Access Compliance Report

| Intersection ID: 27289 | Main Street: ELMSTONE_DR | Cross Street: WILD_DOVE_LN | Location: SE |
| ADA ID: 4CCB8ED40393 | Ramp Type: PerpDiag | Initial Pass/Fail: Fail | Overall Compliance: No |

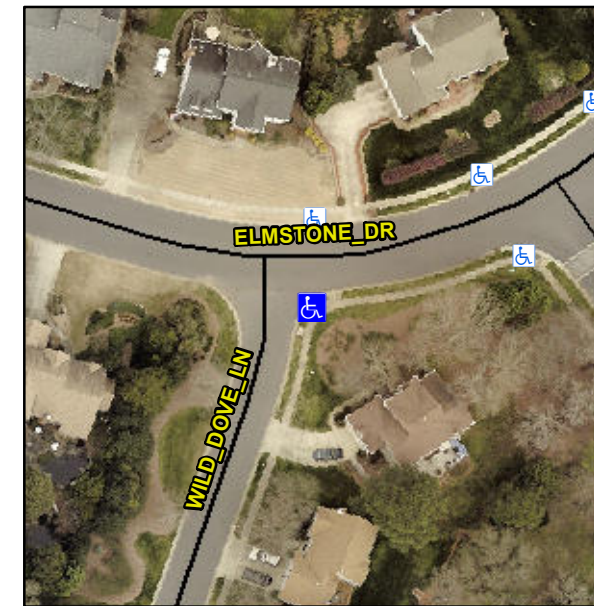
Possible Solutions:

Remove & Replace Curb Ramp With Two New Directional Ramps or Equivalent.

R304.5.3

| Compliance | Description | Data | Compliance | Description | Data |
|------------|-----------------------|-------|------------|-----------------------------|-------|
| Yes | Ramp Width (in) | 48.0 | No | Ramp XSlope (%) | 7.2 |
